Program Bulletin

SB-10057698-4581

SUBJECT: Crank / No Start – DTC U0100, U1000, B2193 Stored

MODELS: 2015 Chevrolet City Express

4100169

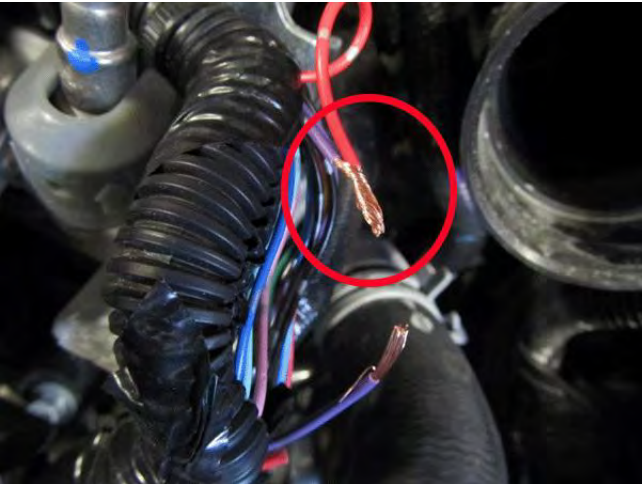
7. Remove the conduit electrical tape on the upper to lower retainer, and pull out the wiring from the conduit. Remove any electrical tape around the wires as illustrated above.

4100174

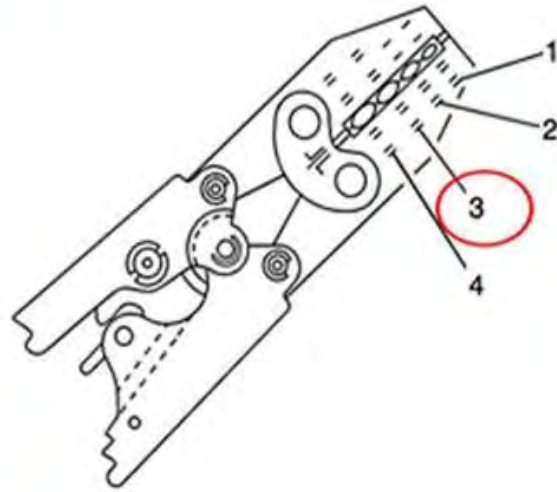
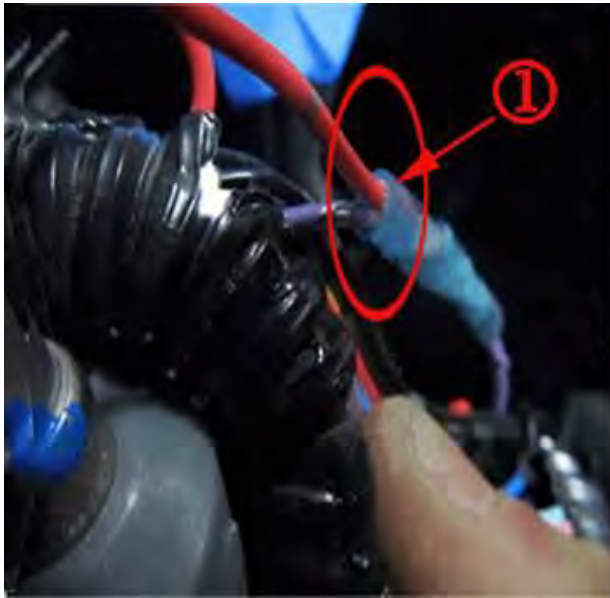
8. Locate the largest gauge **red** (1) and **purple** (2) wires in the harness.
9. Once the wires are identified, cut the **purple** wire (1) approximately in the middle from the removed wires and cut the **red** wire (2) approximately 13 mm (0.50 inch) below the **purple** wire.
10. Strip approximately 5.0 mm (0.20 inch) of insulation from each wire except the lower **red** wire. The lower red wire will have heat shrink tubing installed in a later step.

11. Twist the top of the **purple** and **red** wires together as illustrated above.
